## QUICK PASS CAR WASH JSP24-13

Public Hearing at the request of Novi Road Management, LLC for Preliminary Site Plan, Woodland Permit, and Stormwater Management Plan approval to build a Quick Pass Car Wash.

# PLAN REVIEW CENTER REPORT

## Planning Review QUICK PASS CAR WASH

**203 SOUTH ELEVATION**  
SCALE: 1/8" = 1'-0"

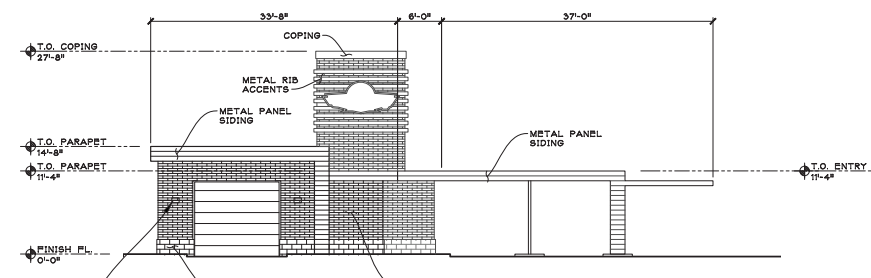
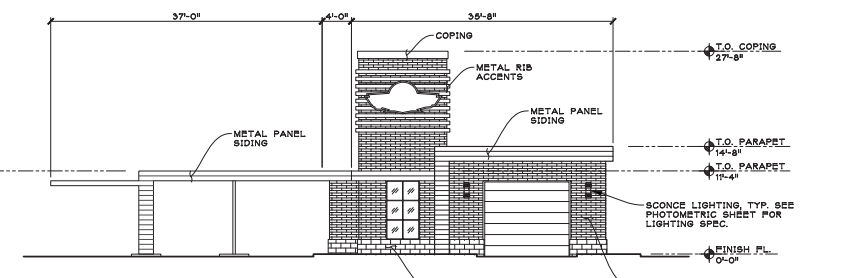
- e. Section 9 Façade Waivers for:
  - i. an underage of brick on all facades, (0% proposed, 30% required).
  - ii. an overage of C-brick on all facades, (45-64% proposed, 25% permitted).

- iii. An overage of Split-faced CMU on the South and North facades (12-15% proposed, 10% permitted). *Supported as it is a minor amount, provided the color harmonizes with the C-Brick.*

- e. Fire Review: Fire is recommending **approval with conditions** of the Preliminary Site Plan with comments to be addressed on the next submittal.
- f. Façade Review: Façade is **not recommending approval at this time**. A Section 9 Waiver is not recommended. Please see Façade review for detailed comments. A façade material board with physical samples shall be provided prior to the Planning Commission meeting.

*The Owners have chosen a mix of three beige C-Brick colors that have a natural color and would create a variation in tone. The façade review comments were that the C-Brick proposed does not have "rich dark earth-toned hues consistent with red bodies fired clay brick," which was not the Owner's understanding of the precedent provided by the façade consultant.*

*contention that since they have selected C-Brick that has natural beige colors and a variation in tone, it would resemble a very common style and color of brick, even though it is not red. Full C-Brick sample boards will be brought to the meeting to demonstrate the actual proposed materials and colors.*

**Attachment A  
Site Photographs**

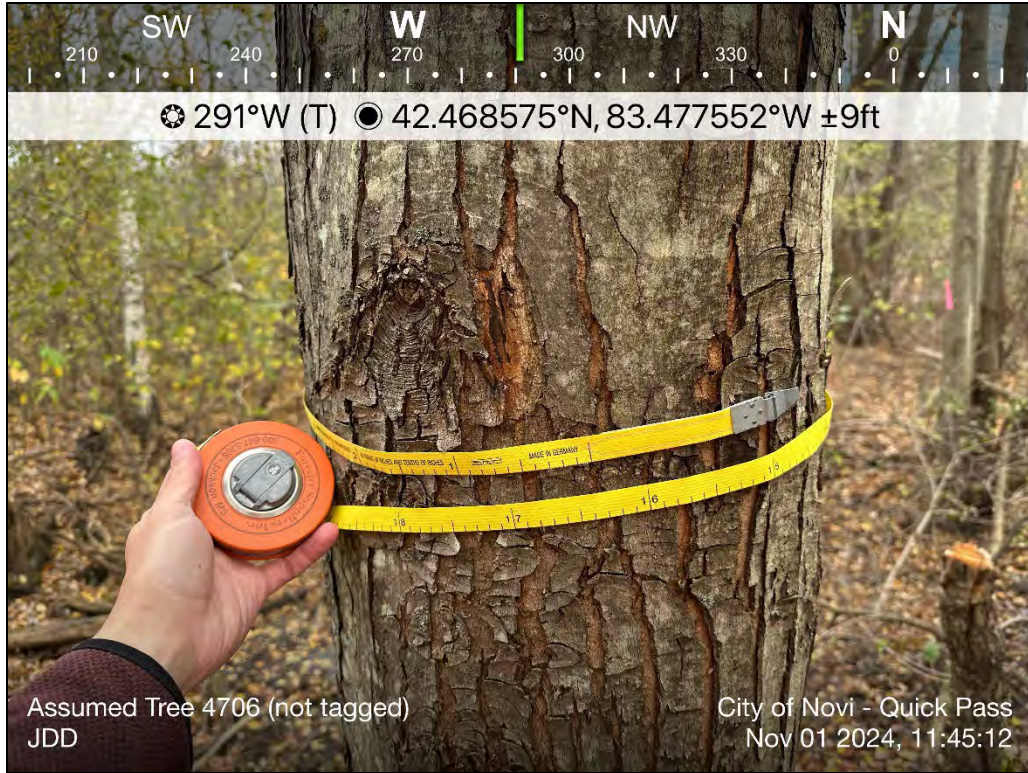
Assumed Tree 4704 with no tag (~14-inch *Ulmus americana*).

Assumed Tree 4705 with no tag (dual trunk ~9-inch *Morus alba*).

Assumed Tree 4706 with no tag (~16-inch *Acer saccharinum*).

Assumed Tree 4707 with no tag (~9-inch *Ailanthus altissima*).

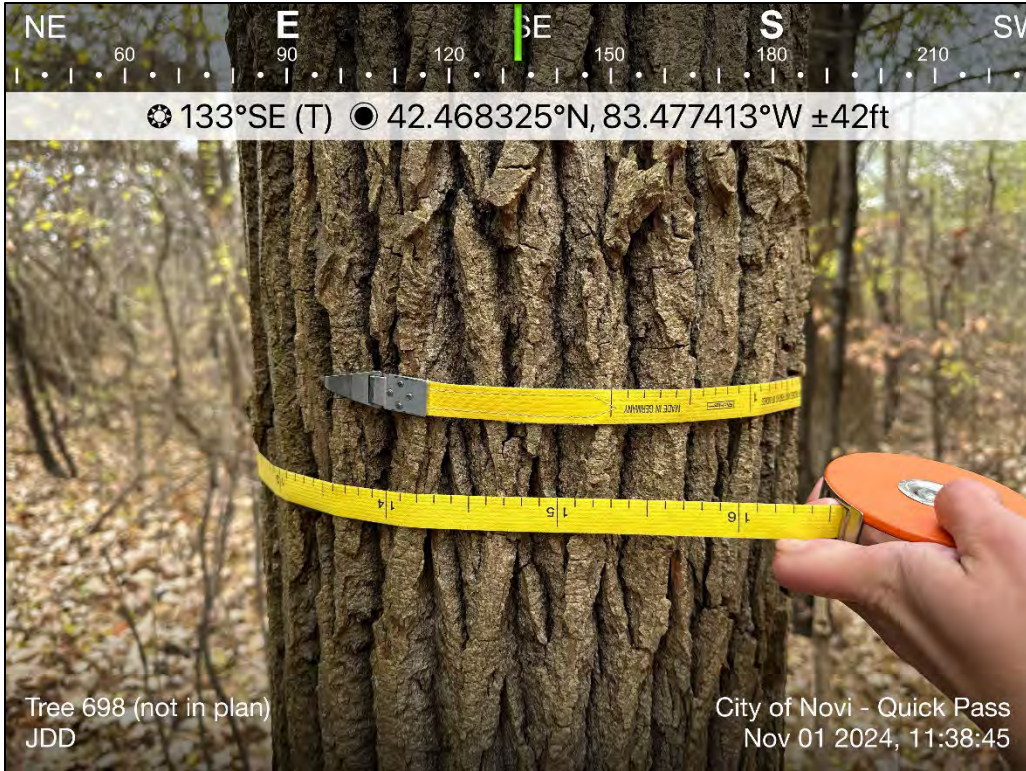
Similar to the PSP Review, very few tattered/ripped and unmarked flags were found on the ground from an old delineation.

Tree tag 698 (not in plan) – a dual trunk *Populus deltoides* (~23-inches [photographed] and ~15-inches)
